**MEMORANDUM****(RA-006-2015)**

**SUBJECT:** Henry County  
JL03 052 0146 002-010  
KY 146 Reconstruction Segment No. 1: KY 153 to Lost Creek  
Mileposts 2.1 to 6.8  
Item No. 5-8300.00  
Mars No. 8304401D  
Geotechnical Engineering Roadway Report Addendum

The purpose of this addendum is to update the geotechnical profile sheets to include the pipe sounding information so the rockline information at these locations will be available to the Contractor. The geotechnical notes sheet will be revised to include a note that discusses the pipe borings. A note will also be added concerning construction methods for shale within new embankments. These revised geotechnical notes and profile sheets should replace the previous versions. The CADD input for these sheets, in DGN format, is being provided to the Design Consultant, GRW Engineers, Inc., for inclusion in the roadway plans.

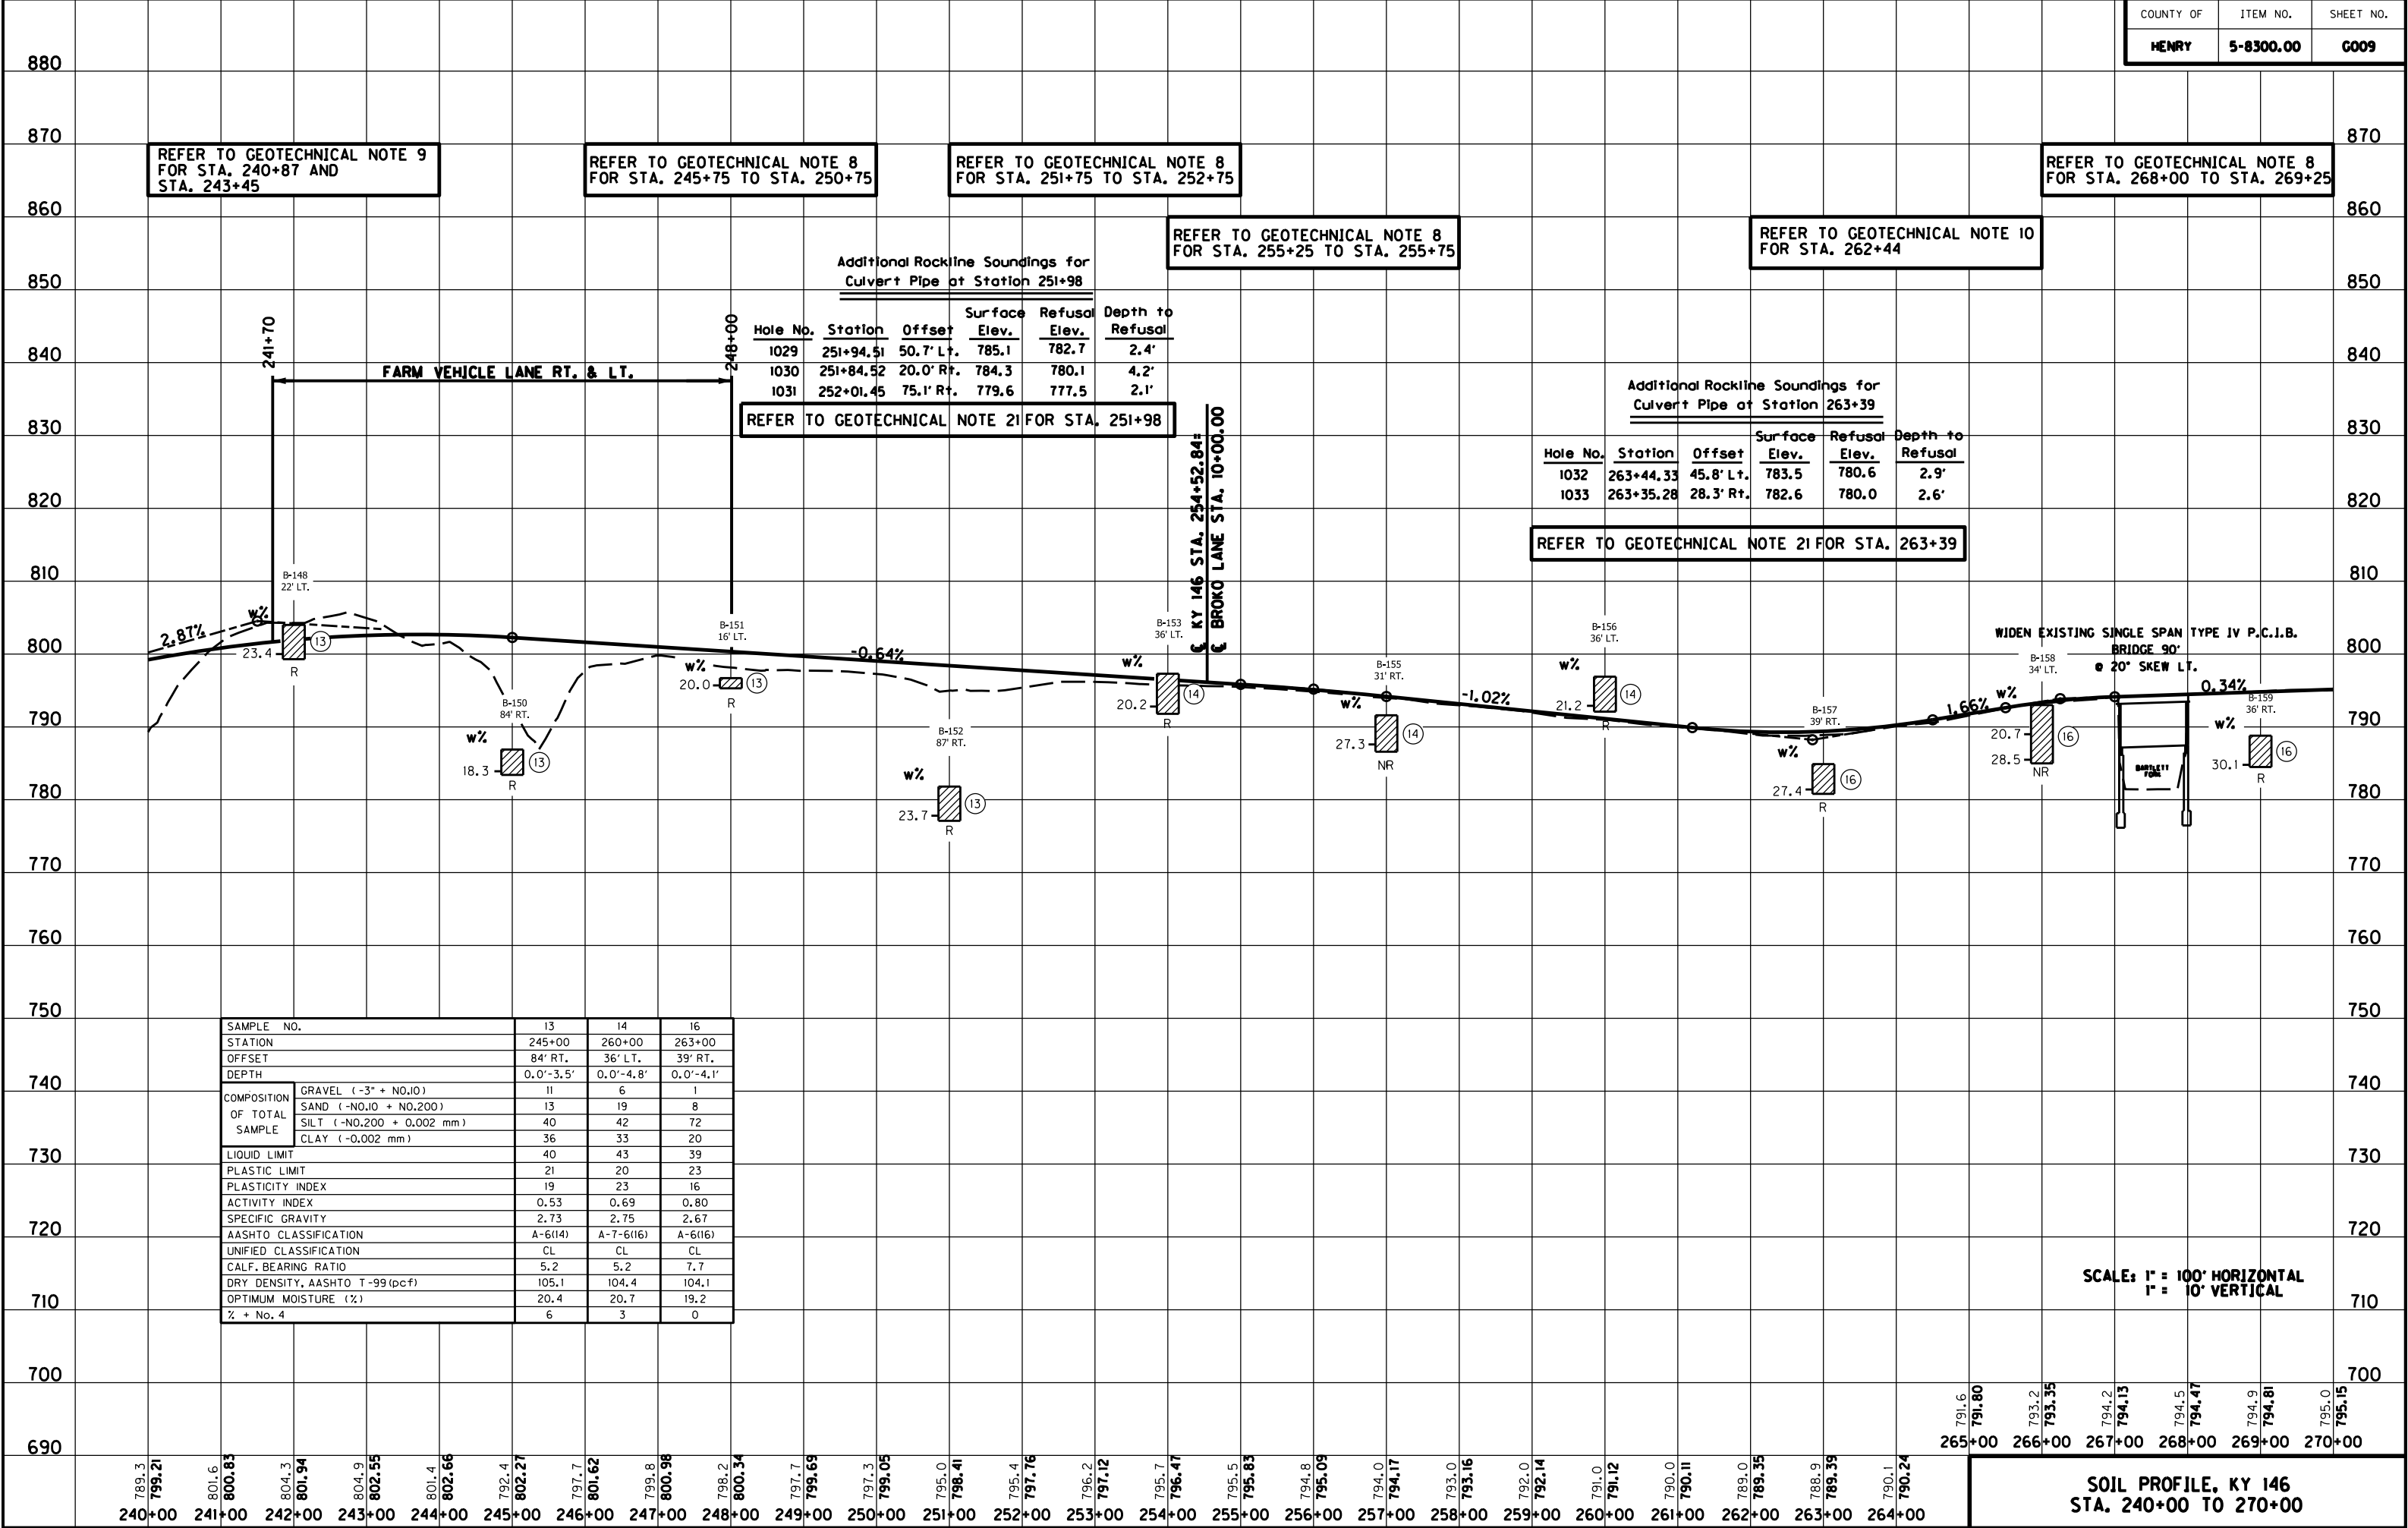
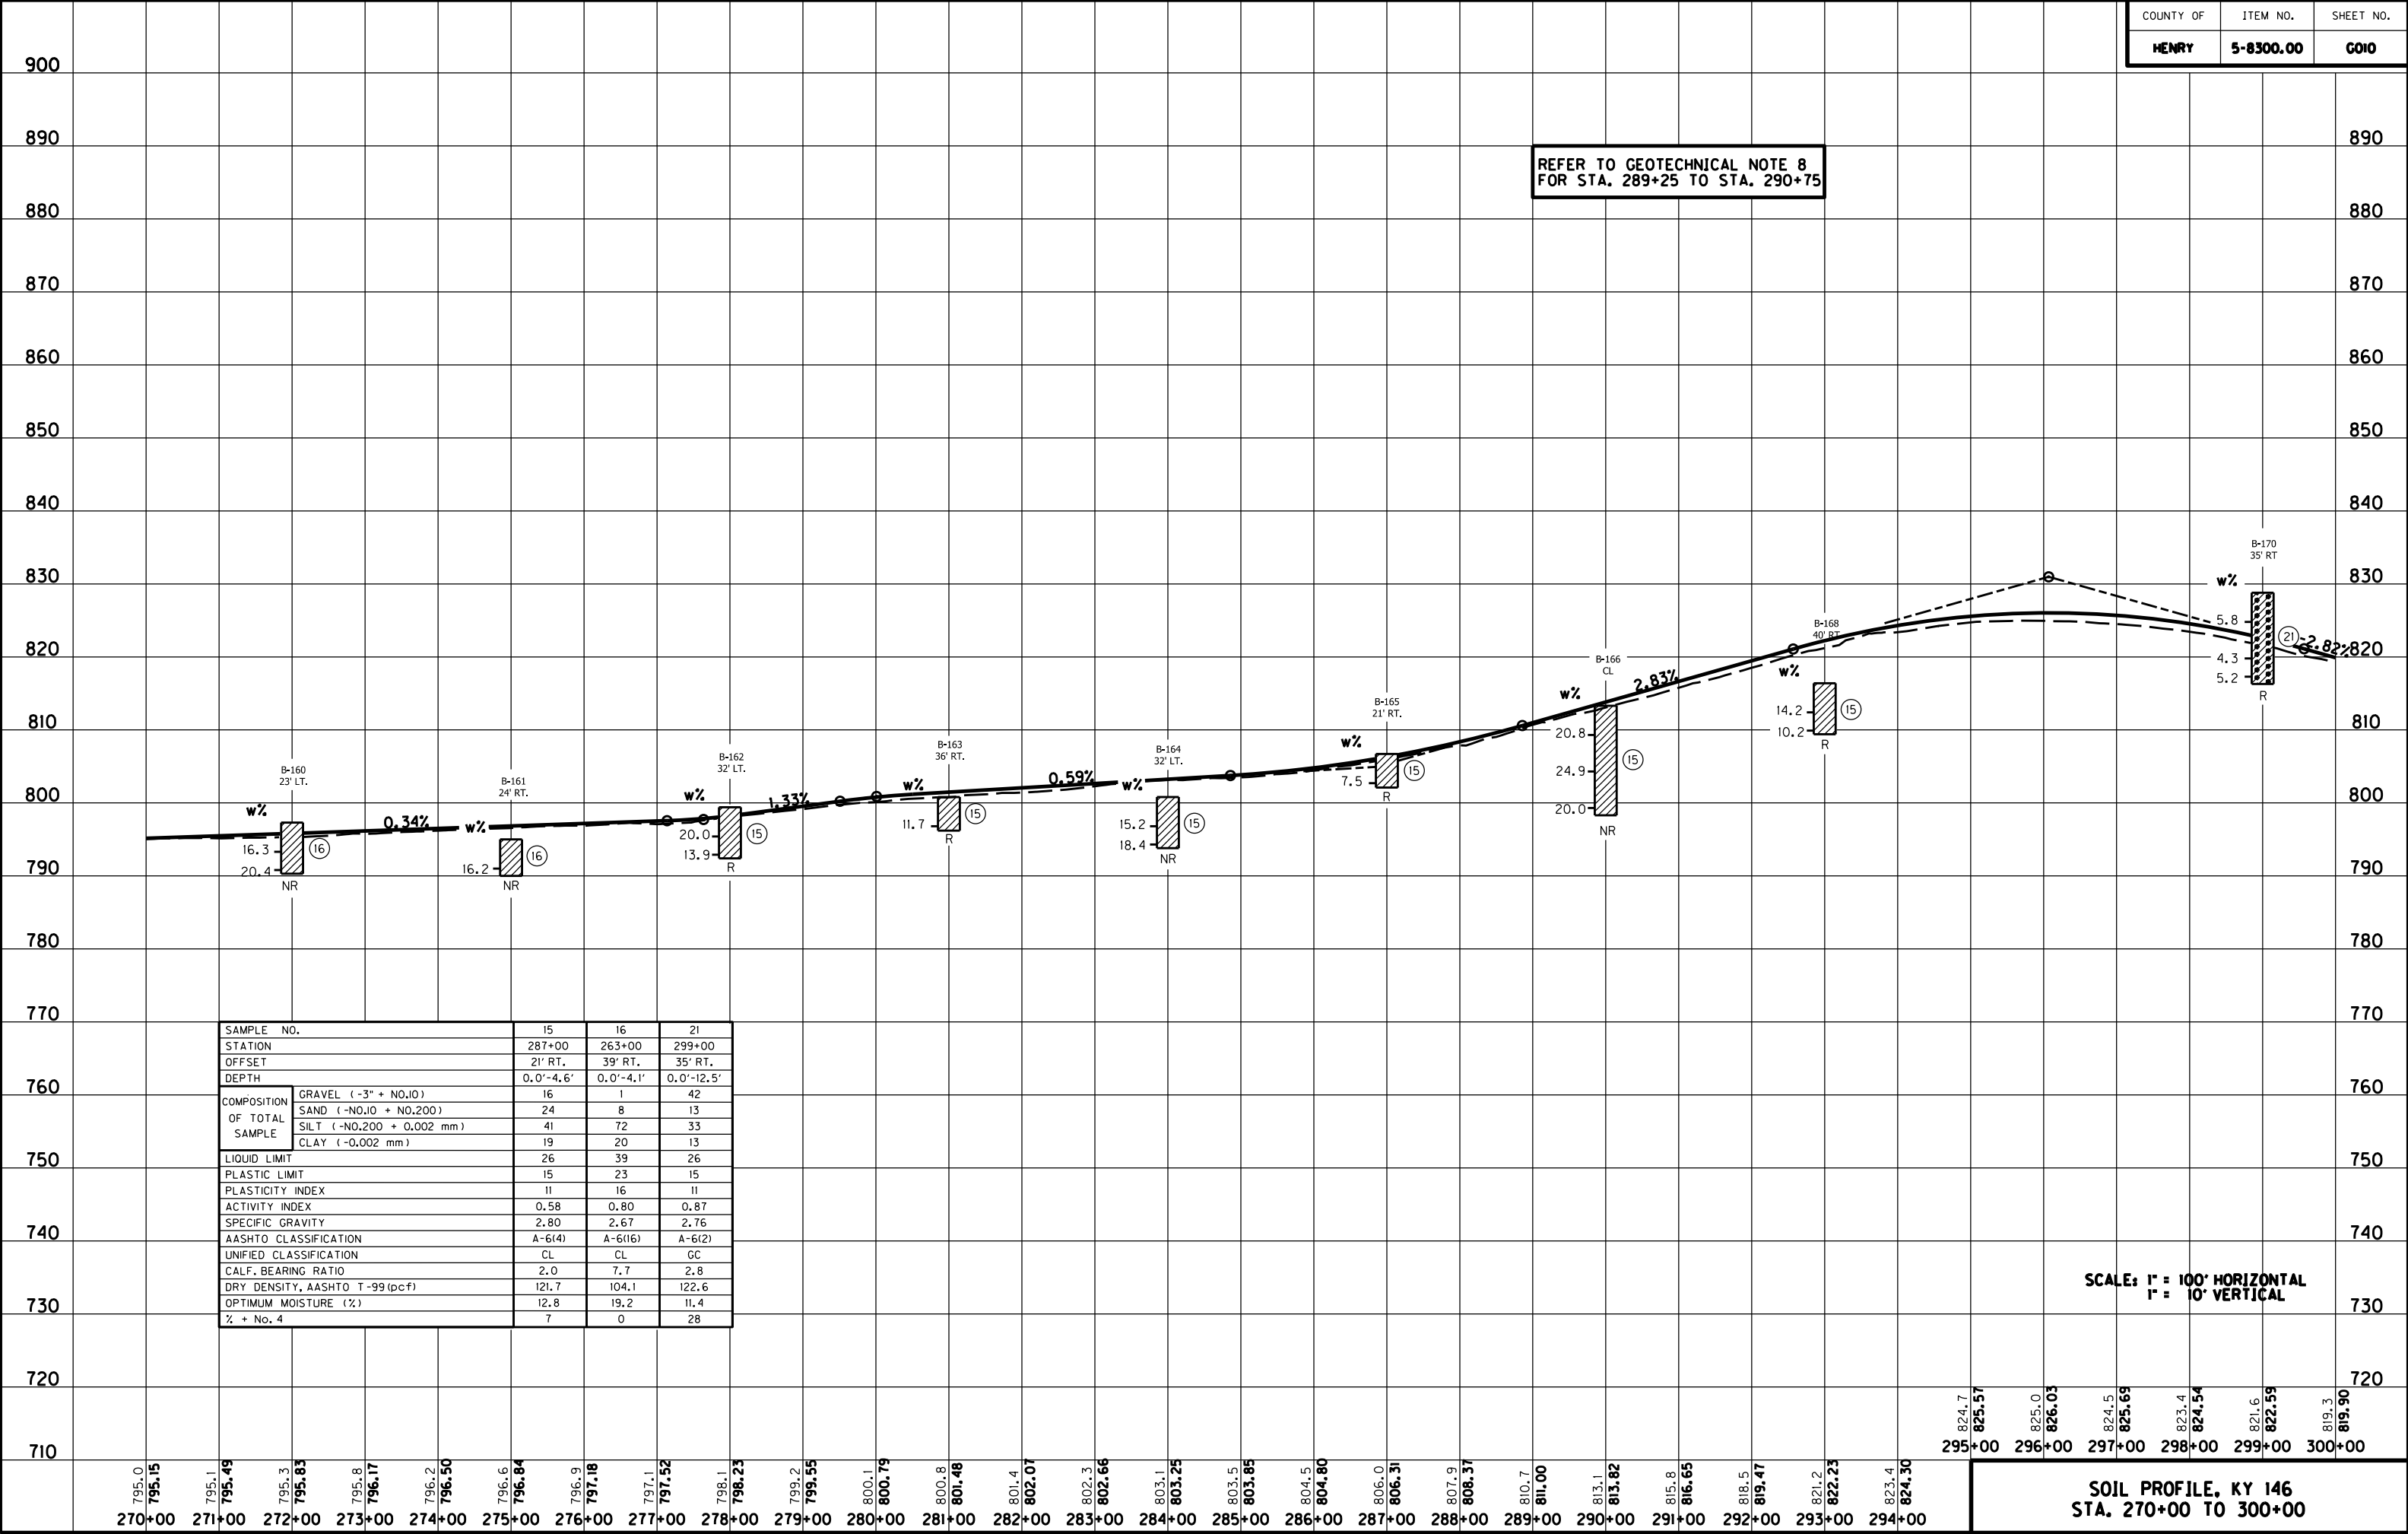
Additional Rockline Soundings for Culvert Pipe at Station 251+98						
Hole No.	Station	Offset	Surface Elev.	Refusal Elev.	Depth to Refusal	
1029	251+94.51	50.7' Lt.	785.1	782.7	2.4'	
1030	251+84.52	20.0' Rt.	784.3	780.1	4.2'	
1031	252+01.45	75.1' Rt.	779.6	777.5	2.1'

Additional Rockline Soundings for Culvert Pipe at Station 263+39						
Hole No.	Station	Offset	Surface Elev.	Refusal Elev.	Depth to Refusal	
1032	263+44.33	45.8' Lt.	783.5	780.6	2.9'	
1033	263+35.28	28.3' Rt.	782.6	780.0	2.6'
